Groundwater Application Review Summary Form

Application # G- 18834

SUBJECT: Application G- 18834 Supersedes review of na
Date of Review(s)

Applicant's Name: **Tiorati MGT, LLC** County: **Deschutes**

Water-Level Trends in Nearby Wells

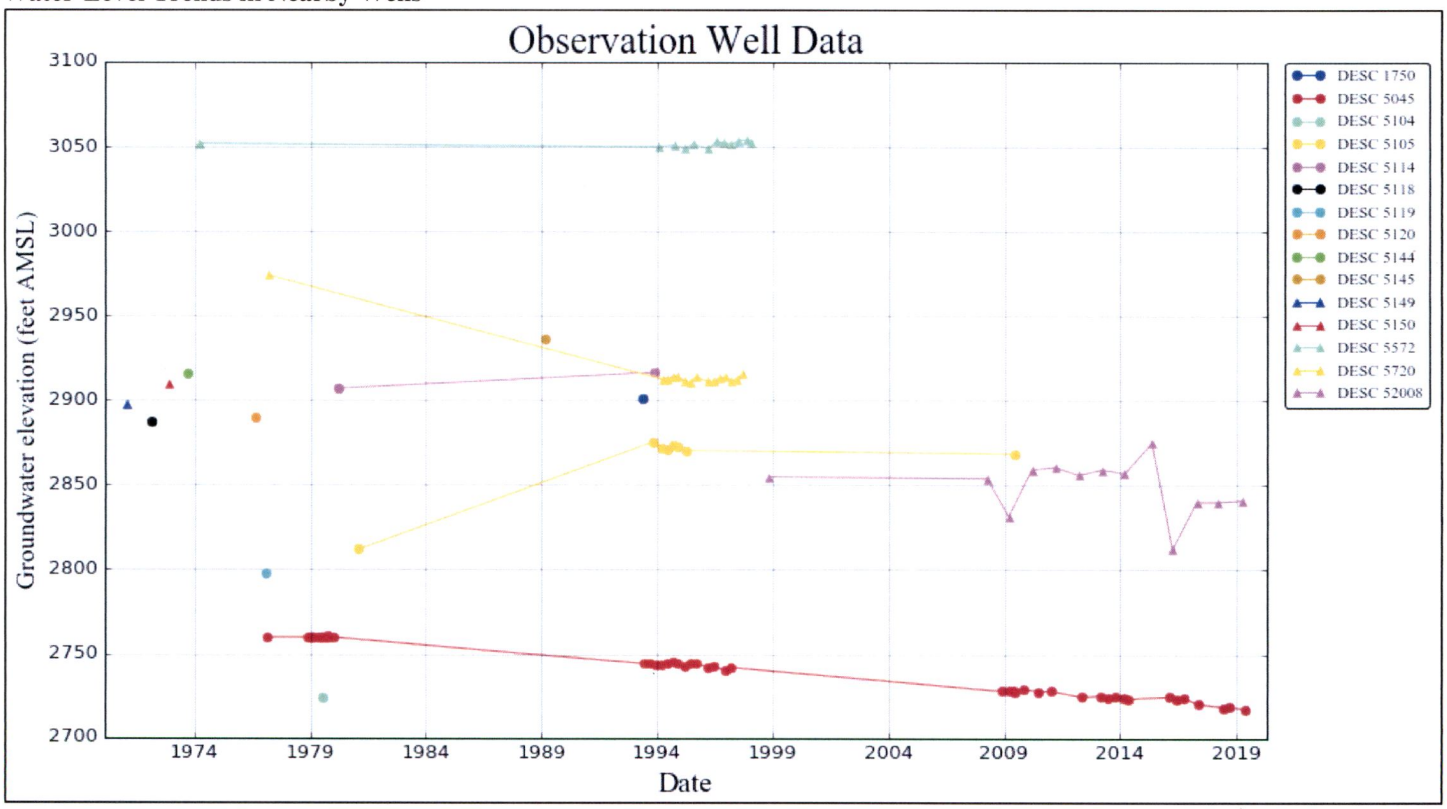
The nearest current observation well, DESC 5045, is located approximately 2-3/4-miles to the northwest. DESC 5045 has been measured periodically since the late 1970's through present. Over the period of record the water-level in DESC 5045 has declined by approximately 43 feet. DESC 5045 is 903 feet deep and is producing from a deeper portion of the Deschutes Formation (regional/basement aquifer) than the applicant's well. The applicant's proposed well is anticipated to be approximately 630 feet deep, similar to most wells in the immediate vicinity which are generally 600 to 800 feet deep. The static water-level in the nearby wells is generally between 500 and 700 feet below land surface with no apparent trend showing groundwater decline (see Well Statistics below). Construction of new wells has slowed considerably since about 2008.

However, two nearby wells (DESC 5572, located approximately 3.8 miles to the southwest, and DESC 5720, located approximately 4.9 miles to the south-southeast) were monitored as part of the USGS-OWRD upper Deschutes Basin groundwater study (1994 through 1996). Over their period of record the water-levels in these wells fluctuated about 2 to 4 feet seasonally. As part of the groundwater study a water-level recorder was installed in DESC 5527 (located in T18S/R12E-3 DD). Analysis of the recorder data shows that the water-level in DESC 5572 responds in a matter of days to operation of irrigation canals which are located approximately ½ mile distant (Gannett et al., 2001, see Figure 35 from this report below) despite the groundwater being over 630 feet below the elevation of the canals. The fractured lava which dominates the subsurface around DESC 5572 (and allows for the rapid response to canal operation) also appears to dominate the subsurface around the vicinity of the proposed well based on the descriptions listed on nearby well logs. The inference is that the water-level in this vicinity is propped up by canal leakage. As more of the canals are lined it is reasonable to assume that water-levels will decline and wells will be deepened. The well log database shows no massive influx of well deepenings in this area as of yet.
